Technical Bulletin - May 2009

VKBA 6868

Rear Wheel: MITSUBISHI Carisma, Colt – 1.3, 1.6, 1.9

### Layout of re-usable ABS Pulsar ring on wheel hub.

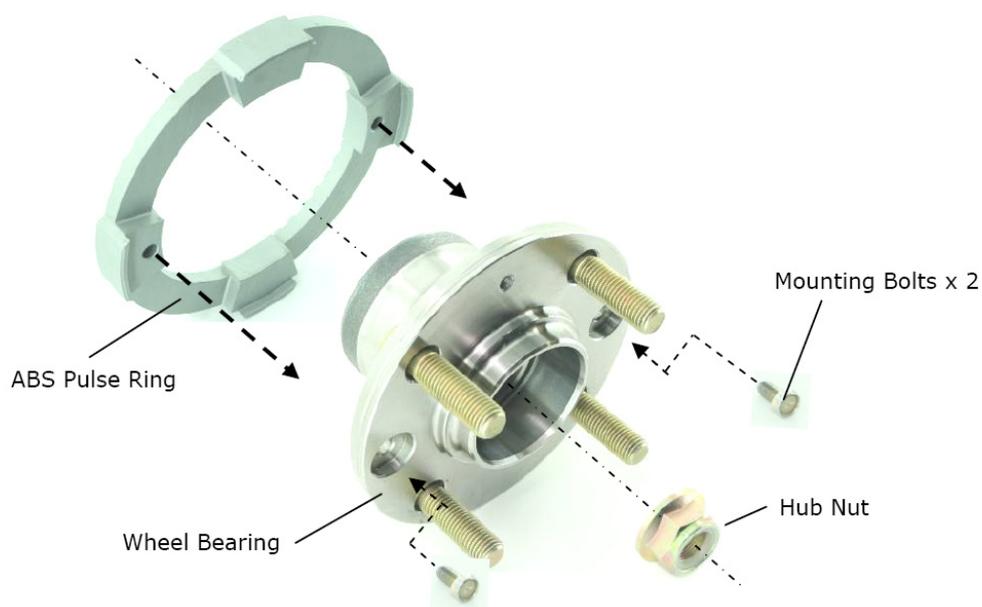
Re-use the ABS pulse ring during the bearing hub unit change.

The OE design and aftermarket equivalent of the VKBA 6868 hub bearing unit, comes without the ABS pulse ring attached. The original component fitted to the hub is re-mountable and only needs to be replaced if it is damaged or broken. The SKF kit content reflects the OES kit composition.
